ADDENDUM TWO

Walb Student Union Partial Roof Replacement - 2026
 Purdue University
 Union Circle Dr.
 Fort Wayne, IN 46815

Commission No.: F26039

Addendum Date: 03 August 2026

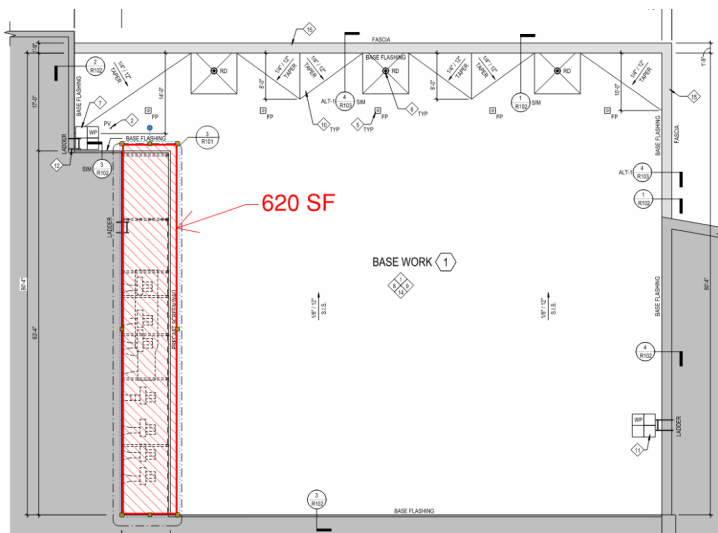
ALTERNATE No. 2 - Replacement of the existing roof within the equipment screen area is to be included as Alternate No. 2. The alternate shall extend approximately 12 inches beyond the exterior perimeter of the equipment screen wall post penetration flashing details, and include approximately 620 SF of roof replacement within the equipment screen area, as indicated on roof plan:

If Alternate No.2 is not accepted, the Contractor shall provide a manufacturer-approved permanent tie-in detail between the existing roof system and the new roof system.

If Alternate No. 2 is accepted, the existing exhaust equipment serving that area may only be shut down for a maximum period of one work week plus two weekends (i.e., nine consecutive calendar days). Coordination with the Owner will be required to establish the shutdown period, which may occur at any time during the project duration. The Project Completion Date should remain unchanged.
